List of Commenters (AMENDED – March 7, 2018)

SUBJECT: Bicycle Master Plan – MCDOT Public Hearing Comments

REVIEW OF MONTGOMERY COUNTY'S DRAFT BICYCLE MASTER PLAN

Figure 2. East MoCo Bicycle Commute 3 mile radius around Primary Employment, Commerce, Recreation Destinations

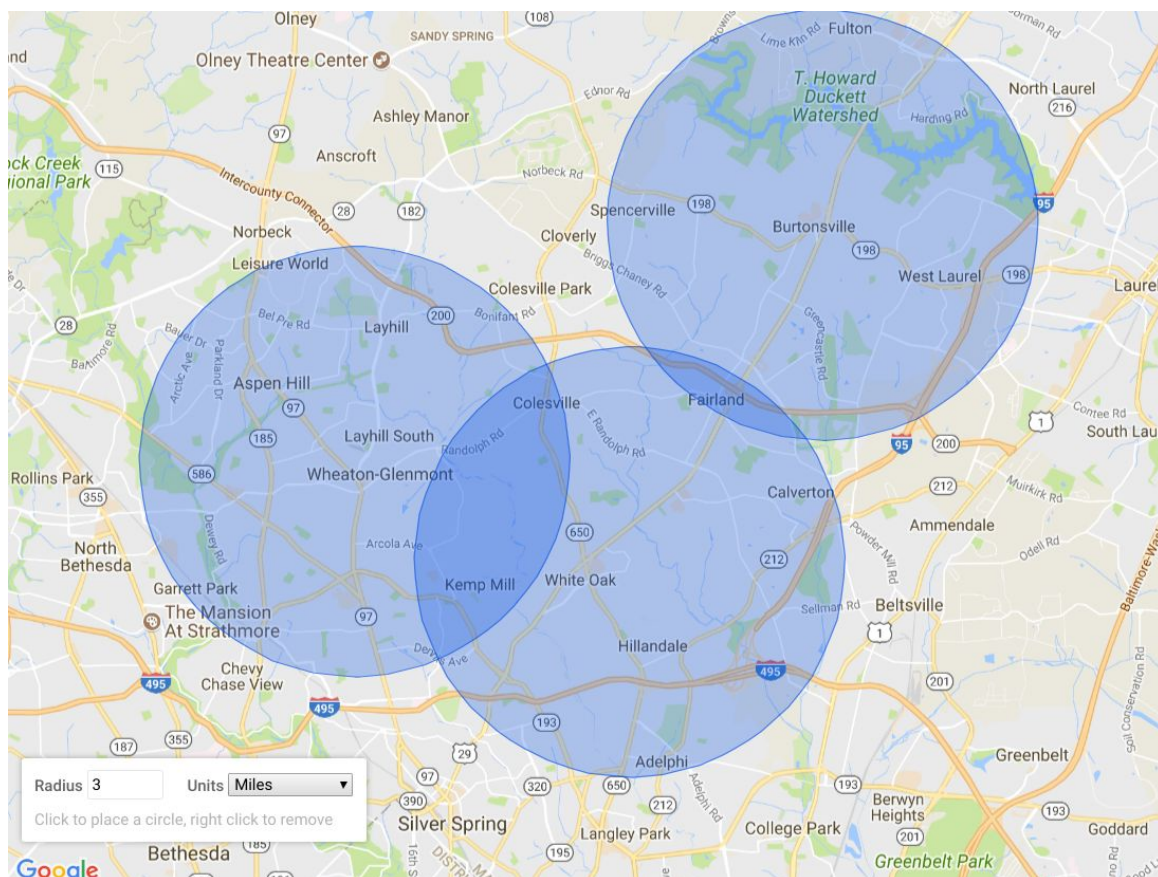
Figure 2 shows a three-mile radius around primary employment, commerce, recreation destinations in East MoCo. Per Census surveys, average bicycle commute time is 20-30 minutes. Average commute time for car drivers living in East MoCo to their job is about 38 minutes (29.4 minutes in Rockville). For most bicyclist commuters, their distance traveled to work is 3-5 miles ([SOTC, 2016](#), Table 14). A few hearty long-range bicycle commuters will travel up to 15 miles with a commute time of about 60-75 minutes. However for most East MoCo residents, bicycle commuters with distances greater than 3-5 miles will likely combine the ride with BRT or METRO to access destinations outside of East MoCo.

The bottom line is we have reasonable bikeable distances to East MoCo education, commercial, work and transit destinations, thus **when** high quality level of service bicycle infrastructure is built, we will see significant adoption of bicycle commuting as a transit choice.

Figure 4. East County Bike Plan Neighborhood Bikeway Suggestions

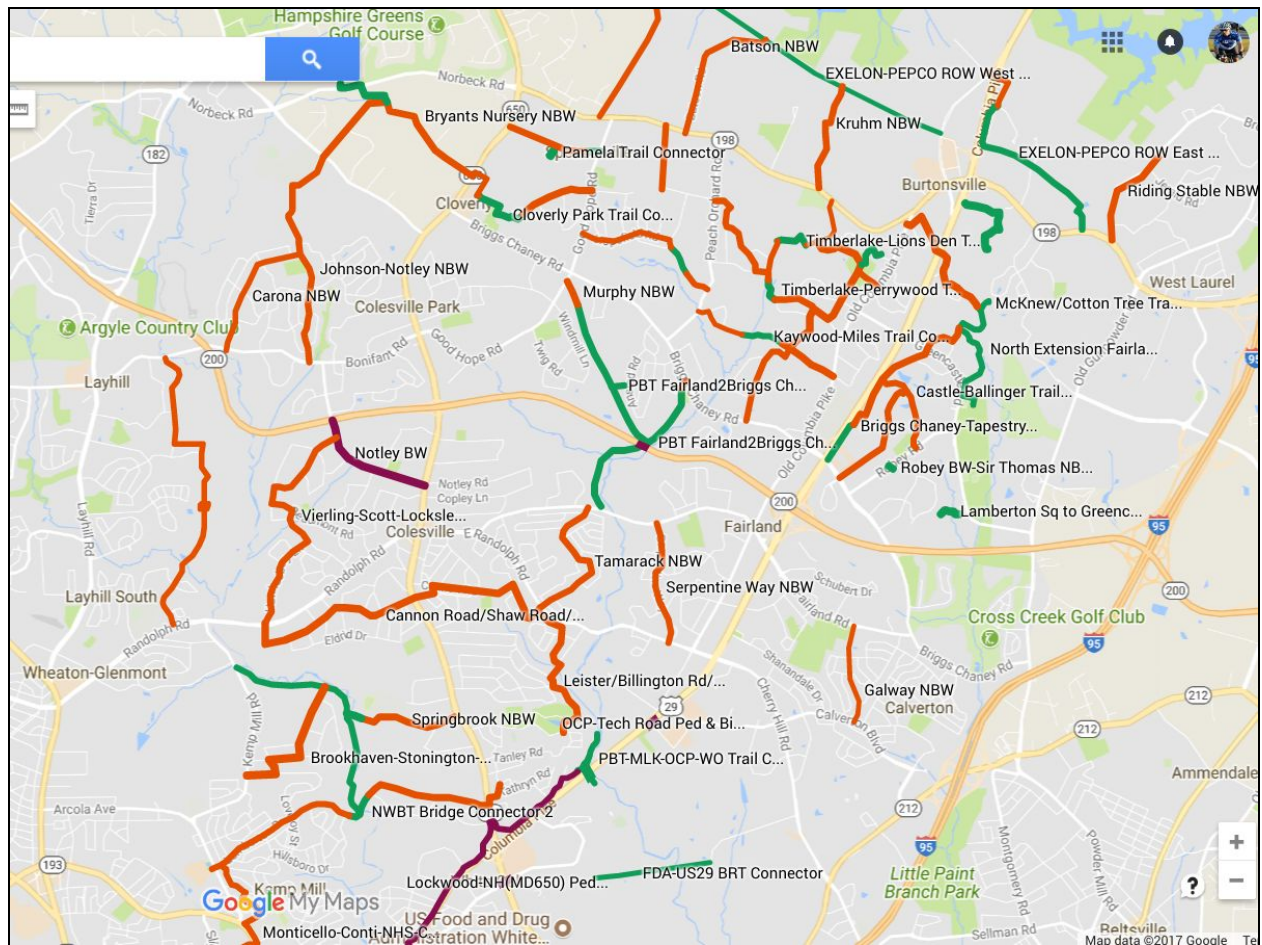
Figures 4. and 5. provide thumbnails of detailed graphical depictions of our recommended bicycle infrastructure to be included in the Montgomery County Bicycle Master Plan. We encourage your team to review the detailed recommendations that we have catalogued in the following media:

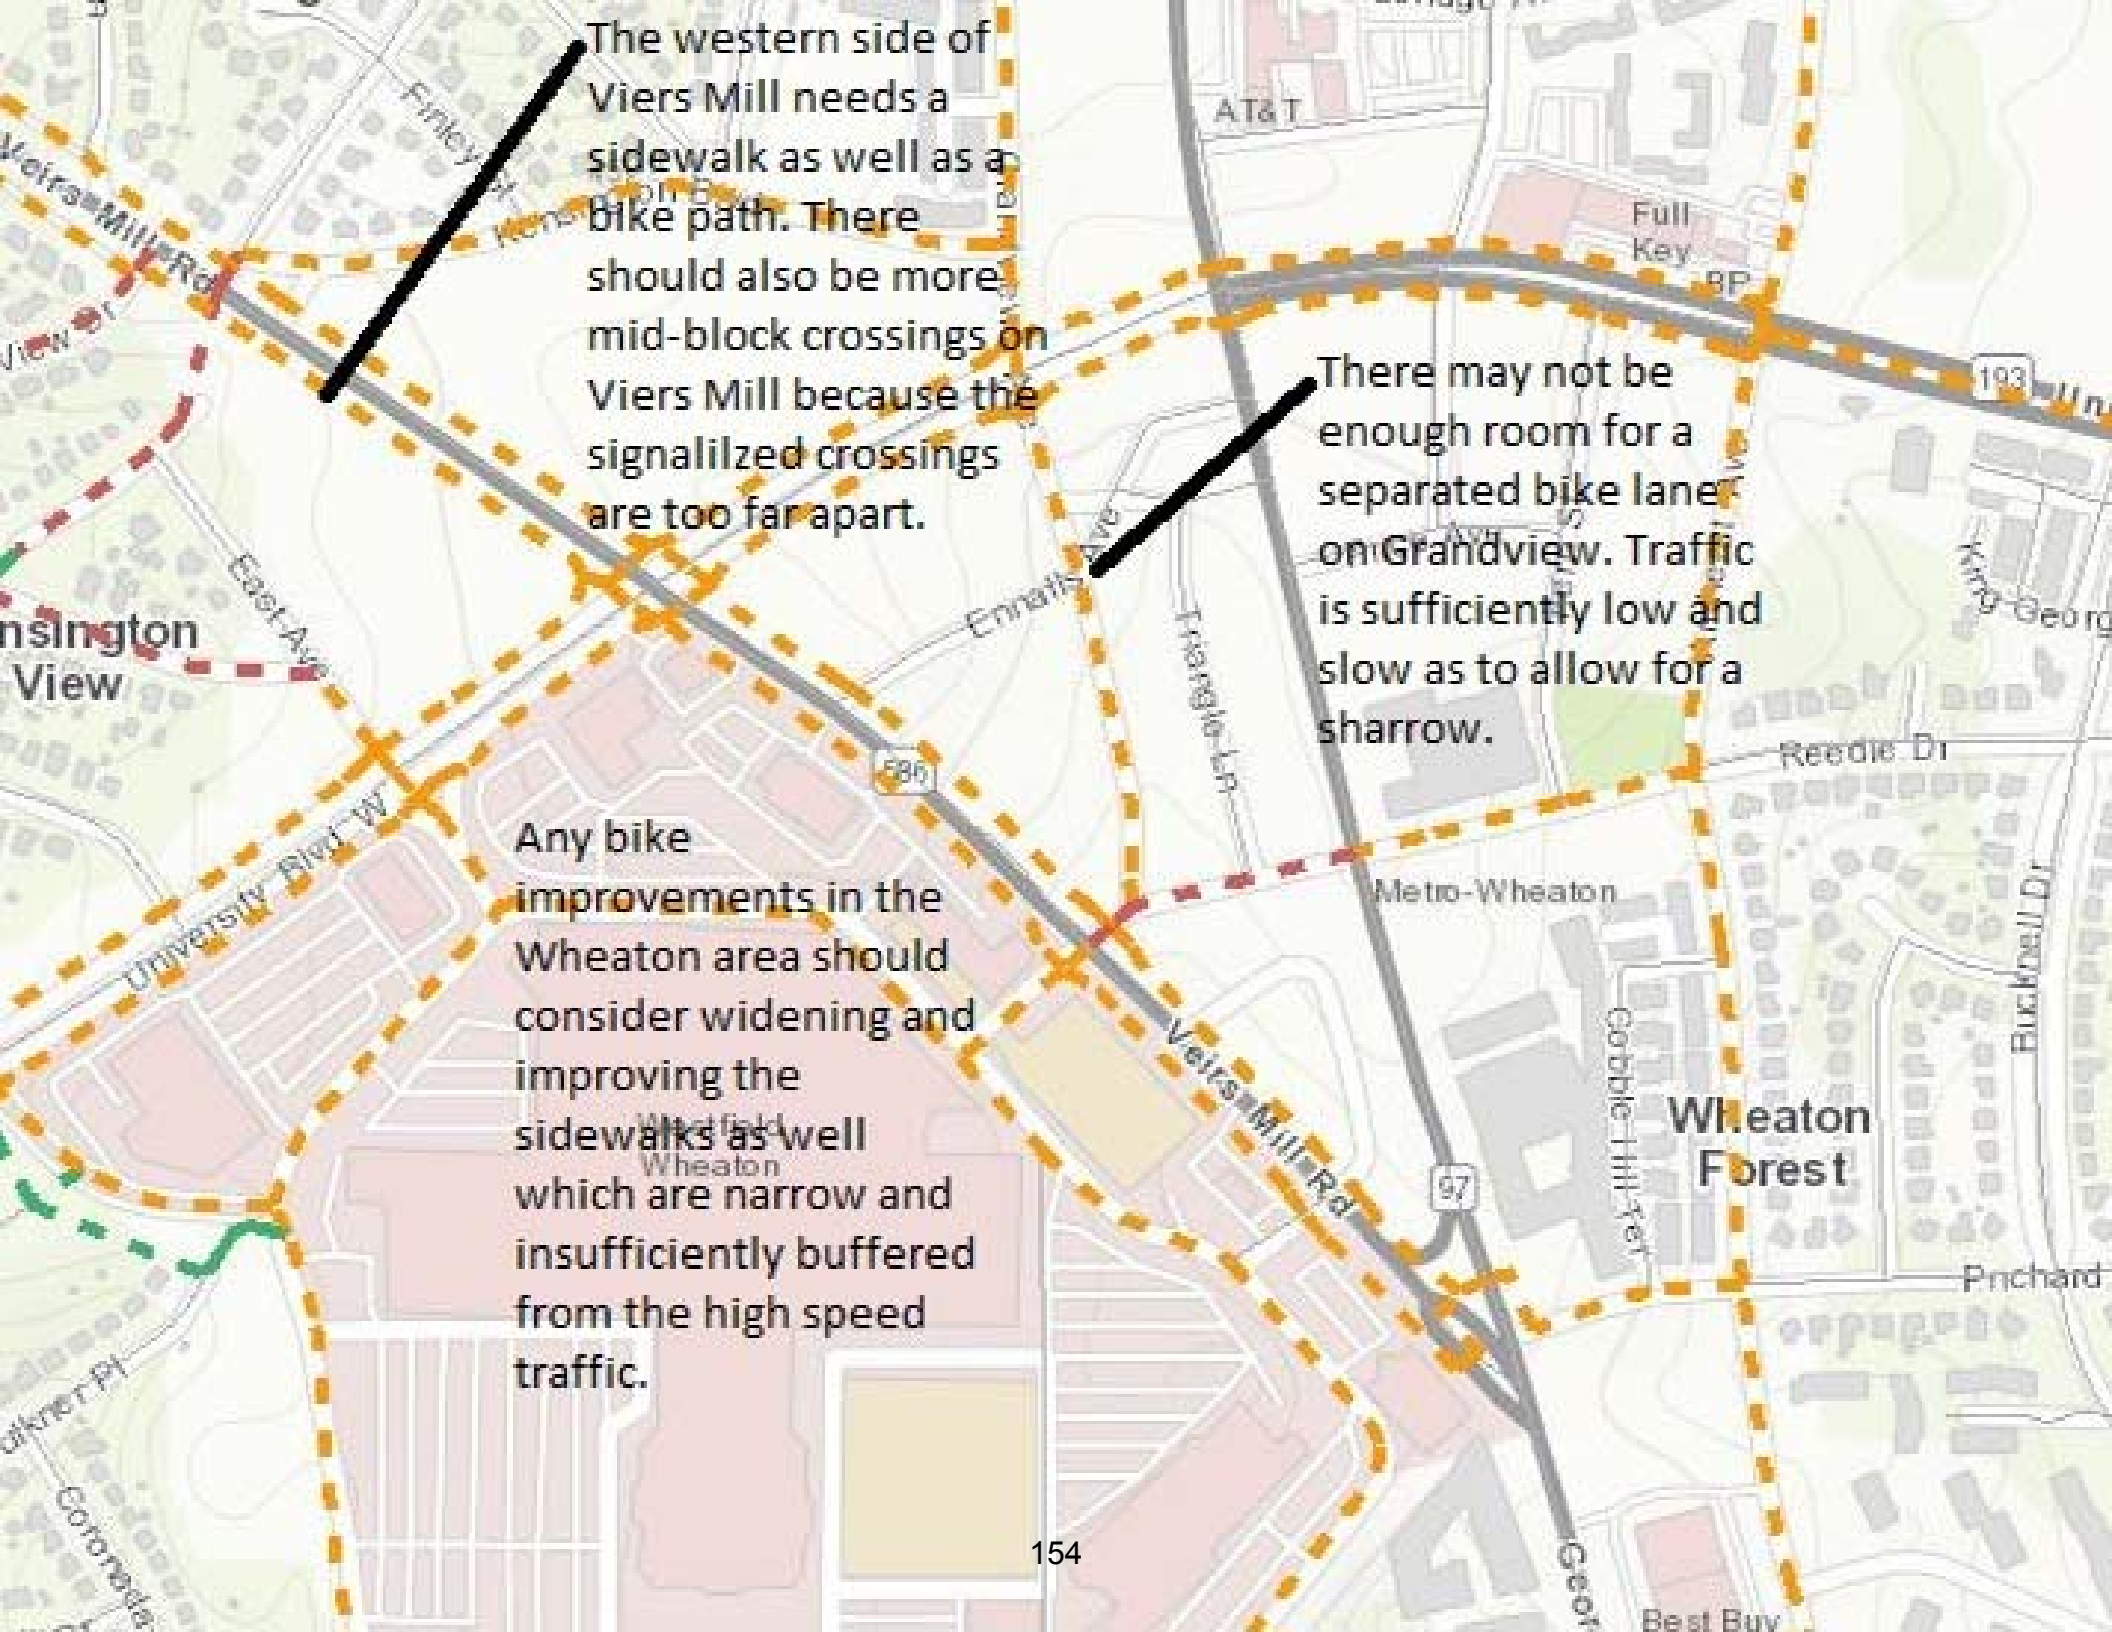
Add a new bike path connection from the terminus of Kenton Drive to the parking lot at the end of Upton Drive.

Connect this new path to the existing path along the existing park fence.

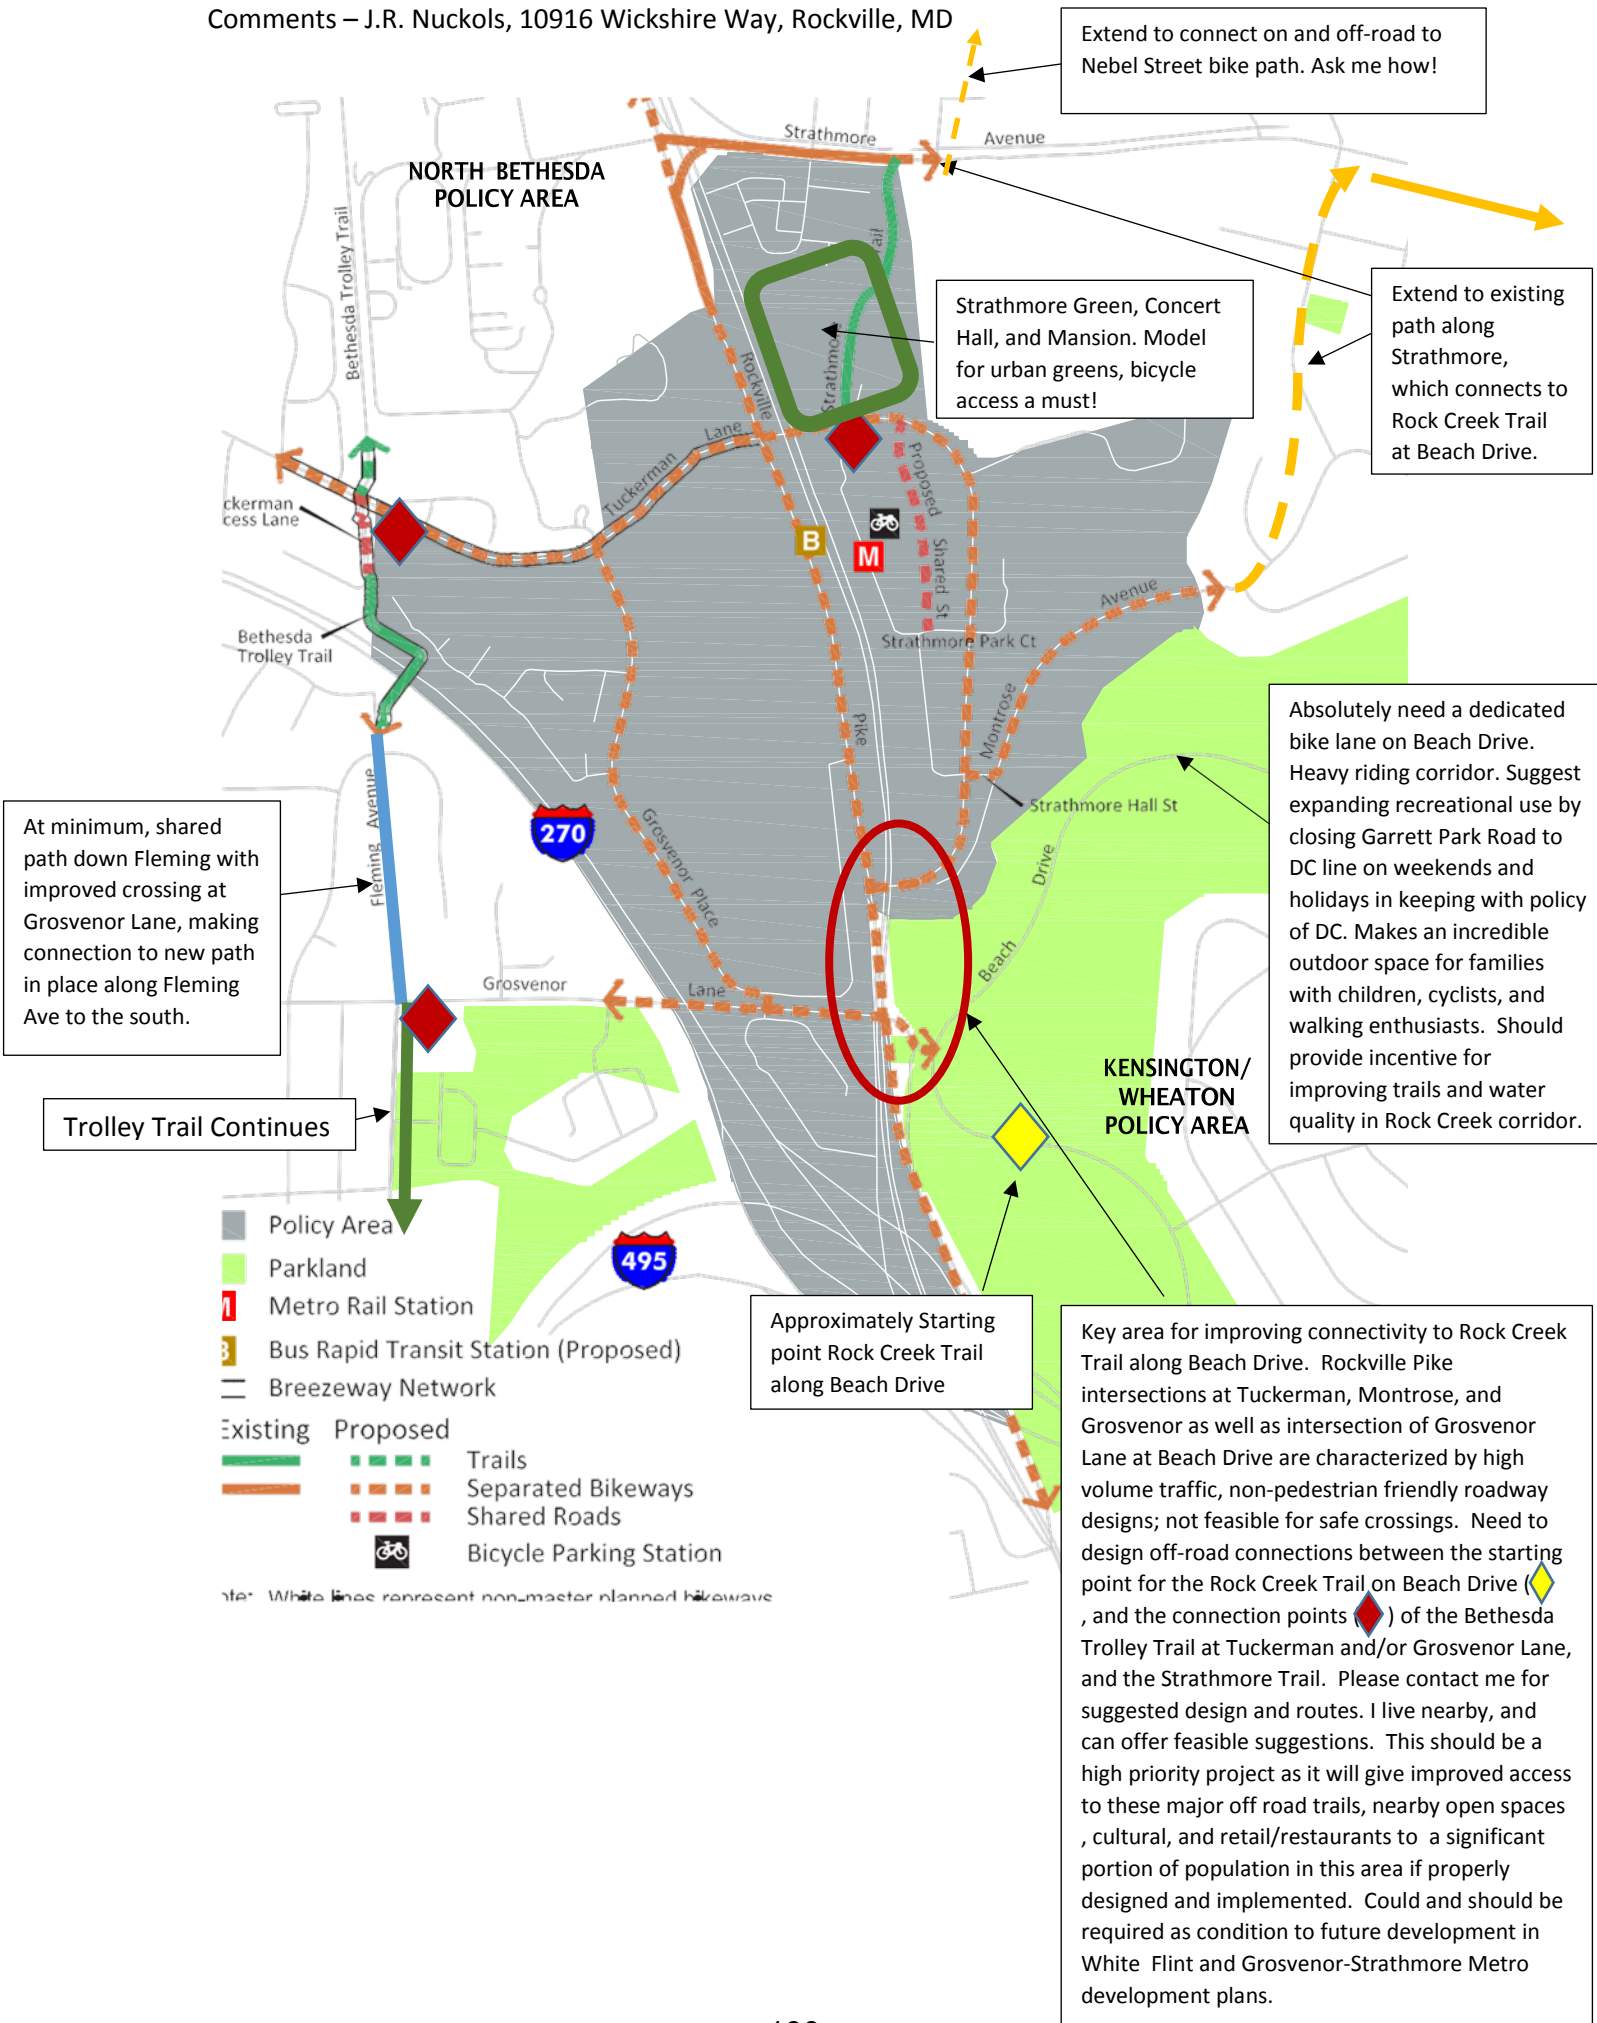
Attached please find my specific recommendations for improving the plan towards the above goals in the Grosvenor Planning Area (P. 290) in the report.
